Slim Edge for LGADs

EIC-Related Generic Detector R&D Proposal Review Meeting

October 20th 2023

Modified termination:
(several variants will be designed)

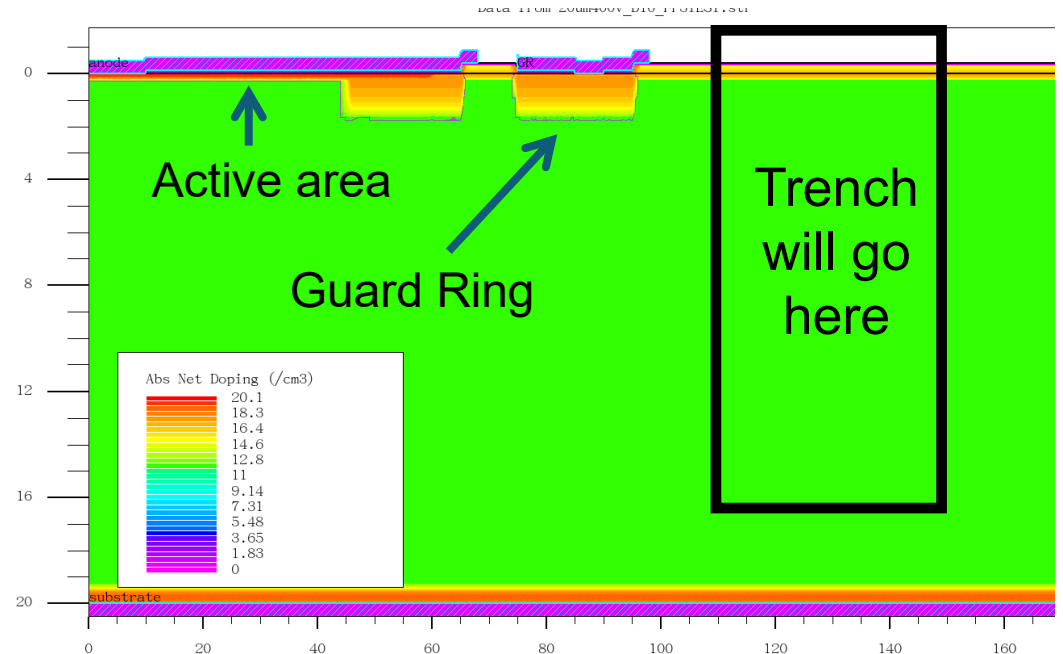
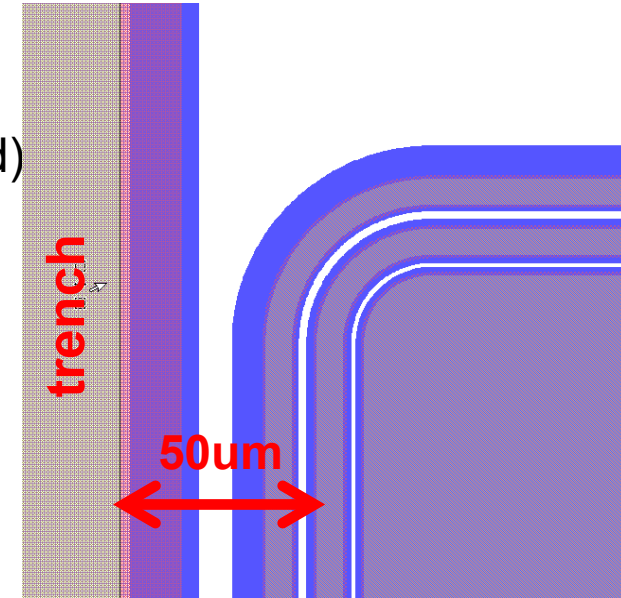
Explain in more detail the designs of the edges.

Standard termination, even for a 20um thick substrate

- termination down to 1 floating guard Ring
- shrinking (or elimination) of grounded GR
- Substrate contact smaller and closer

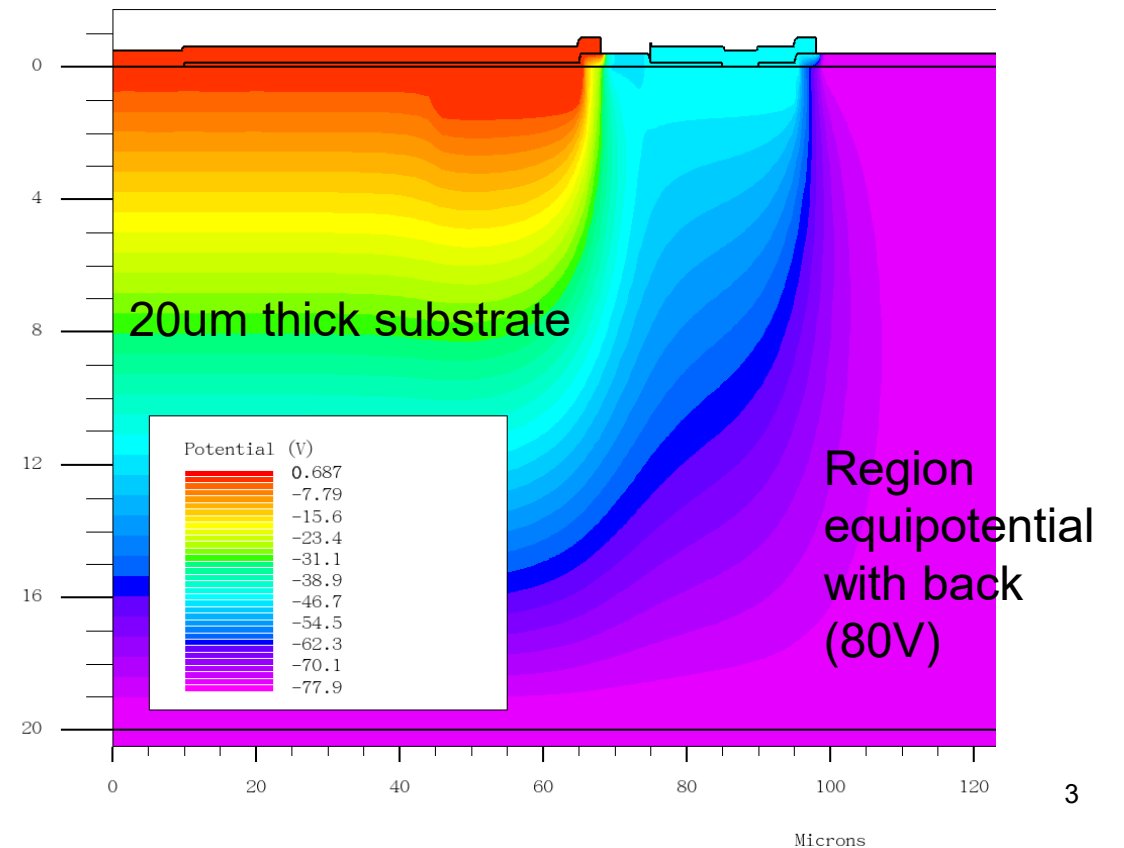
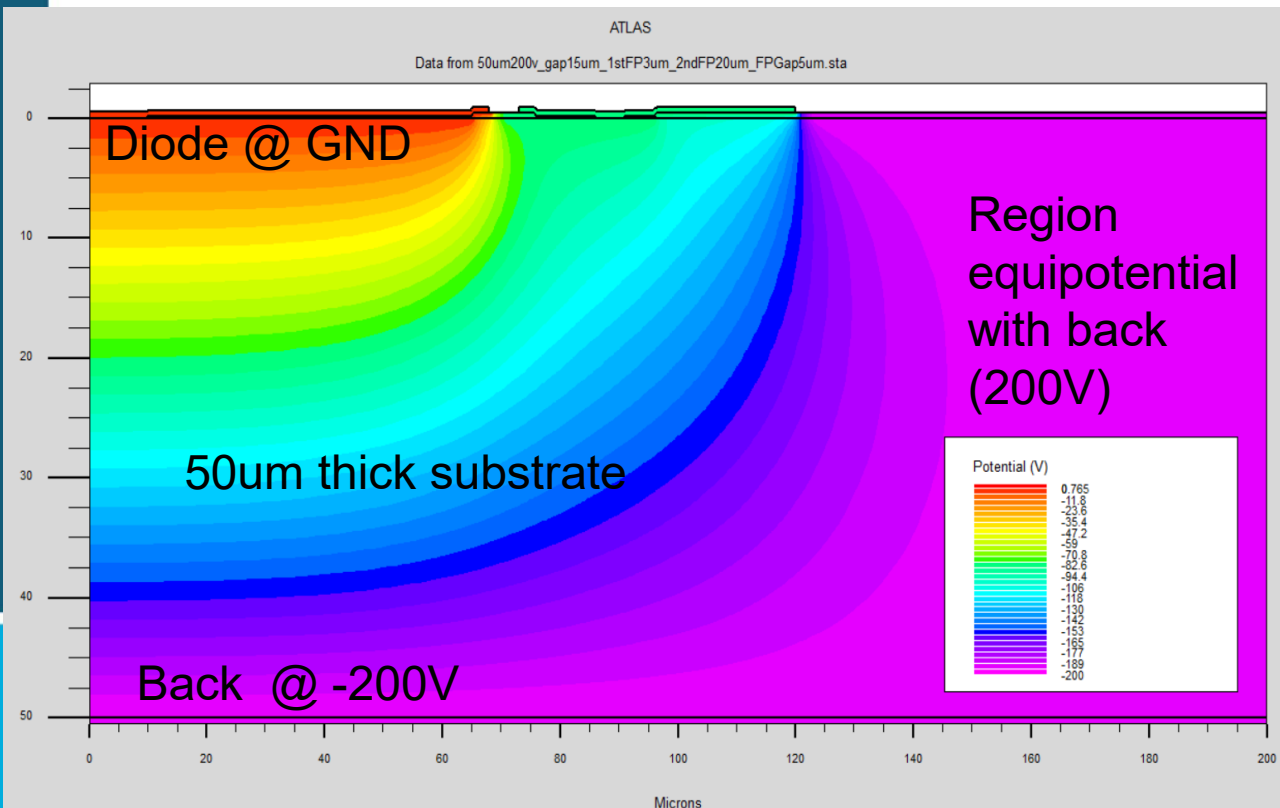
Is simulation supporting your choices?

Yes, a great deal of TCAD simulations was already carried out by a SULI student this summer (J. Duncan, U, Memphis).

Depletion region hardly extend beyond one GR which is within 50 μm from grounded area, even at high voltages.

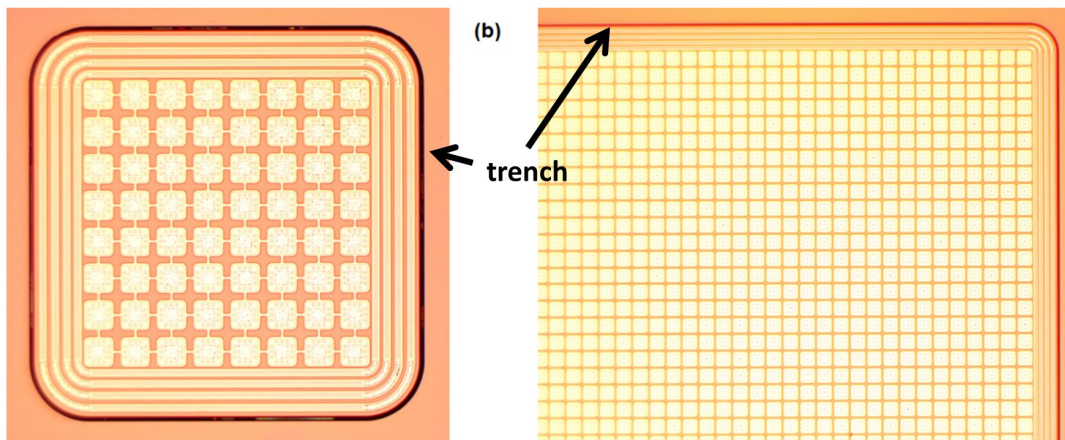
Why do you not include DRIE (Deep Reactive Ion Etching) in the program? Such a machine may not be available at BNL but they are widely available at University fabs. Inclusion would make the project more complete.

Although we don't have experience in DRIE, we can certainly profit from this project to gain some. DRIE will require – beside the facility – a furnace for boron diffusion (not a BNL either, but we are users of, for example, Cornell Nanoscale Facility <https://www.cnf.cornell.edu/> - so the process can be carried out at Cornell), and PECVD filling to planarize the surface and allow several other lithographies (contact opening, metal, passivation opening).

It is certainly a very elegant and working solution, but it takes some effort (need 100% of funding).

Example of process

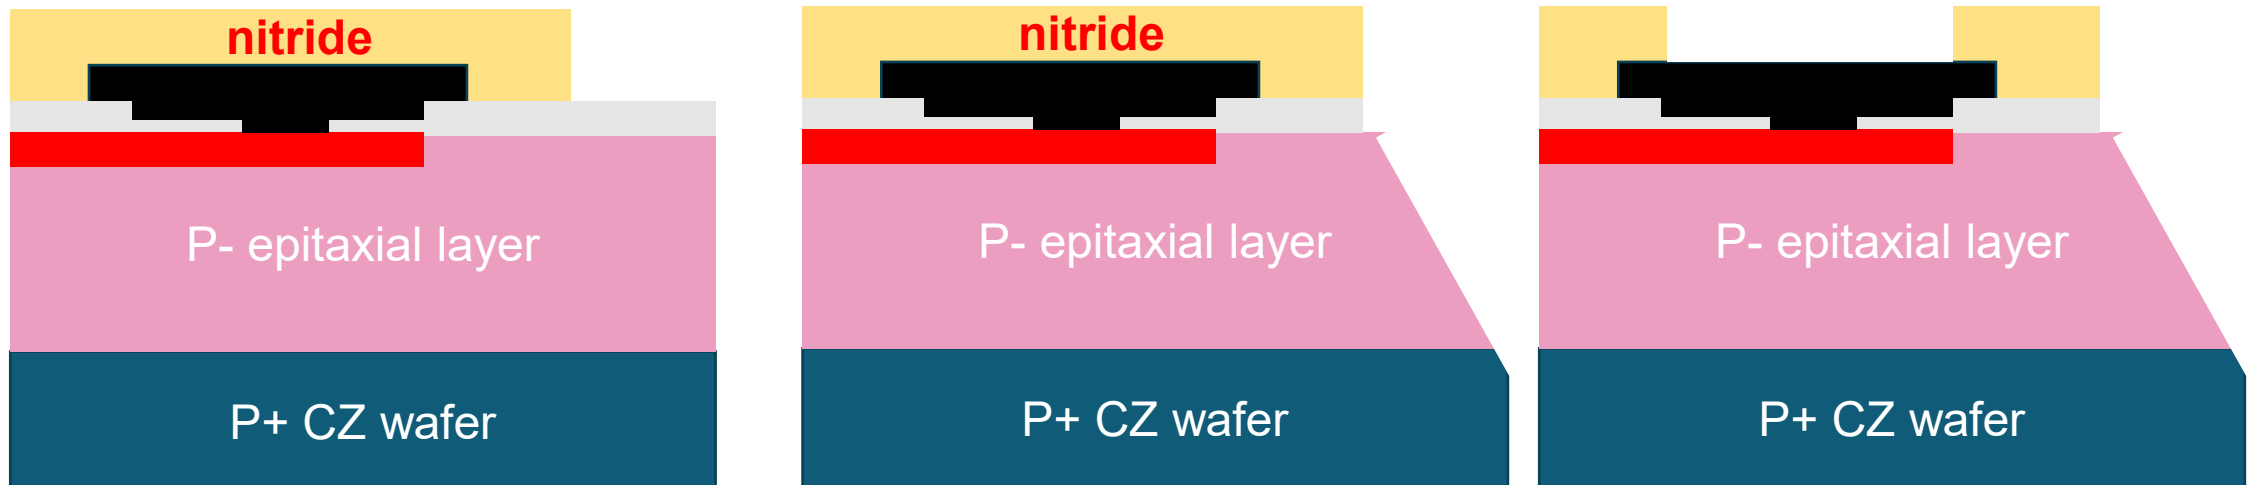
What lithography is needed after the trench etch? Can it be the last step?

Yes, passivation opening will be the last step.

To resist the KOH attack, a layer of nitride (~ 100nm – already tested) will be deposited. Then we have to open the nitride in the pads area, for testing and contacting. This requires litho.

Leakage Current vs Voltage for 20 Micron Substrate – 1 Guard Ring only

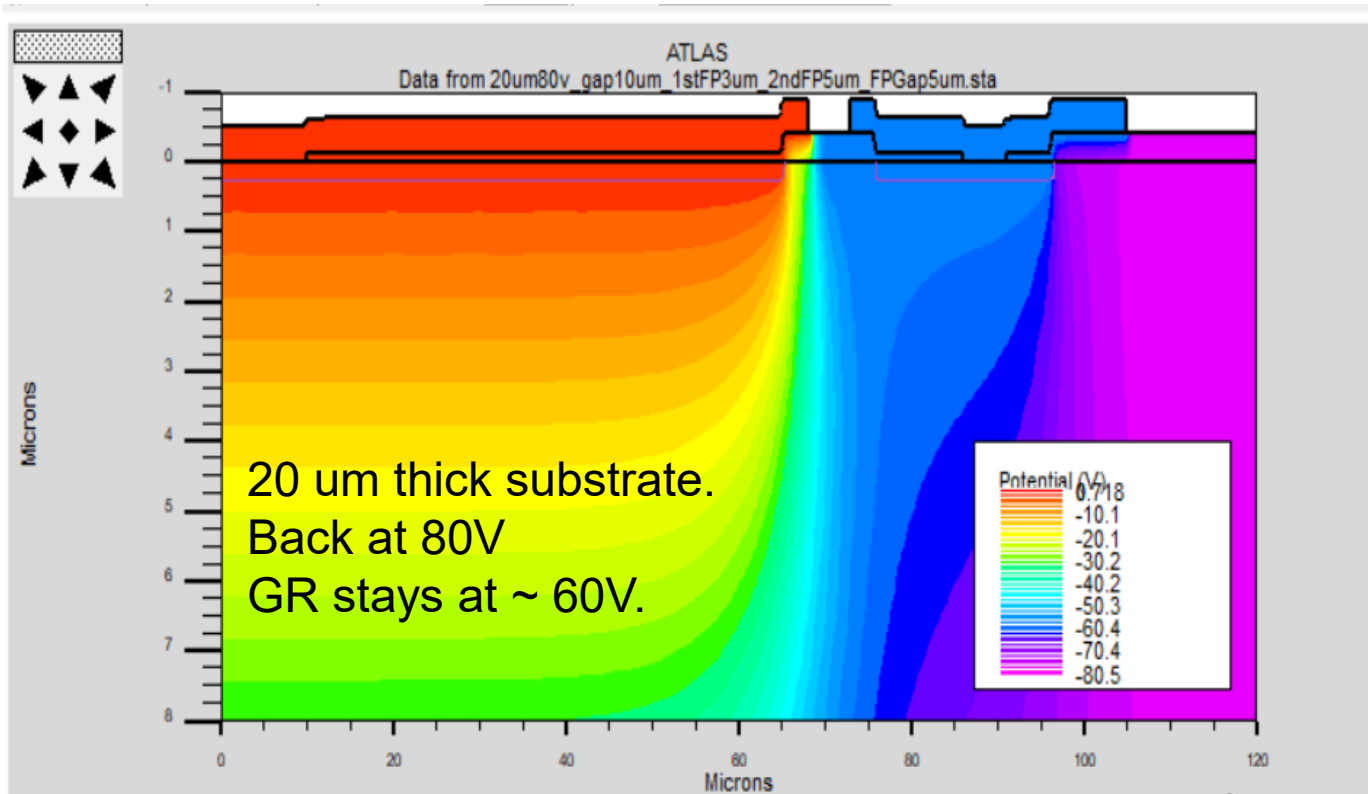
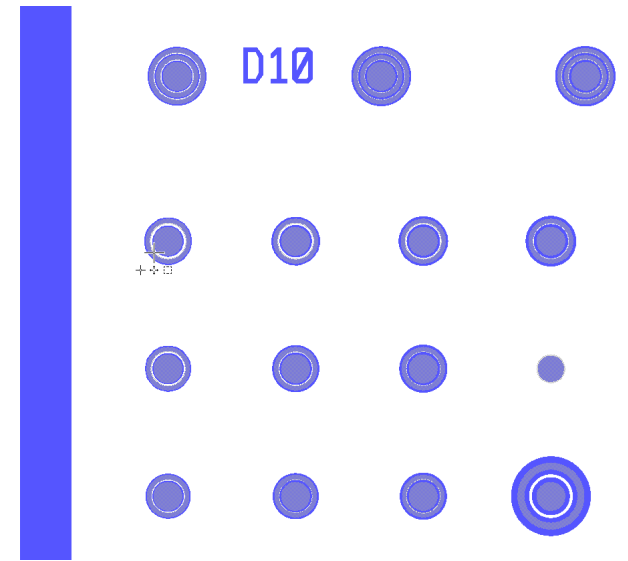
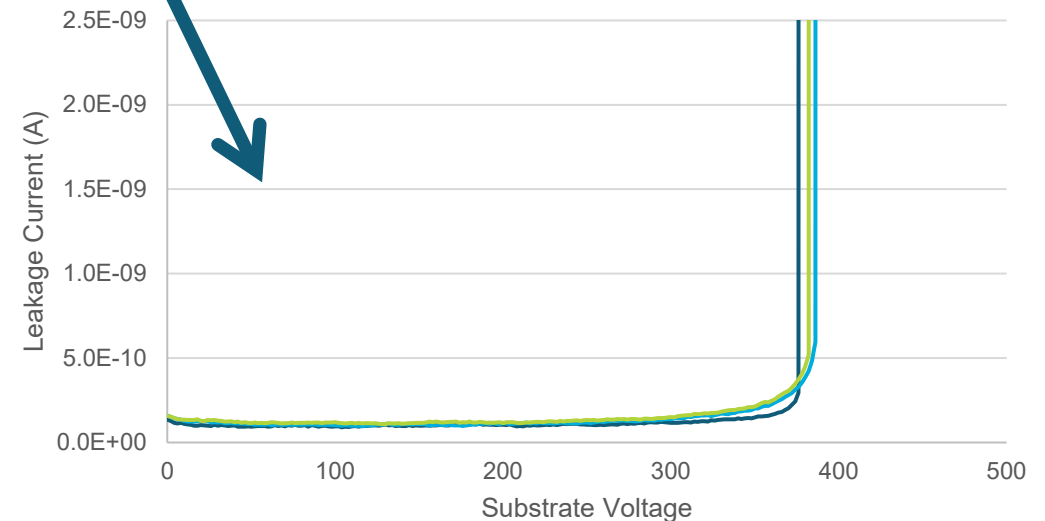
What guard ring geometry do you plan to use? How much space does it take?

In the wafer, there will be placed many design variants, however we'll focus on few GRs, closely spaced, order of $\sim 50\mu\text{m}$ or less.

TCAD simulations suggests that, if the substrate is thin, GRs are hardly biased at all.

Measurements on test structures tell that 1 GR is enough to sustain very high voltage.

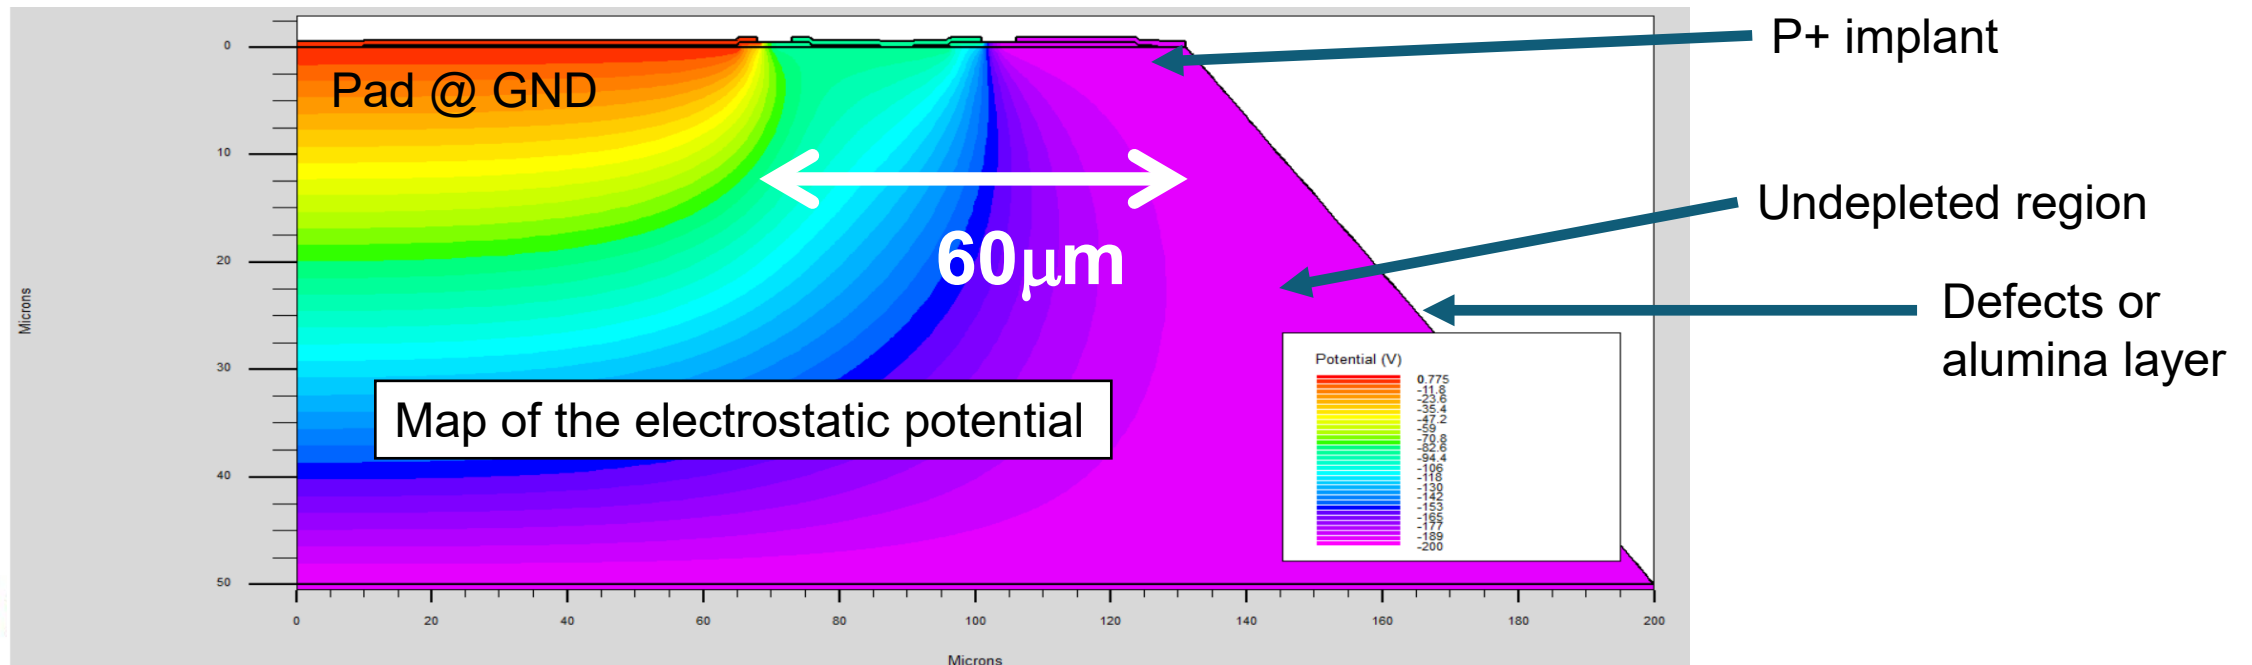
Can the trench be used to isolate the backside from the front so that the front side is at ground potential?

Not in the present plan: both the substrate and the epitaxial active layer are p-type.

The voltage applied to the back propagate to the front side because of:

1. the etched/diced wall of the scribeline/trench due to defects
2. by the hole accumulation layer induced by the alumina passivation layer.
3. by the undepleted region at the border (equipotential to the back).
4. at the top surface, at the edge of the device, a p+ layer terminate the surface and is equipotential to the back.
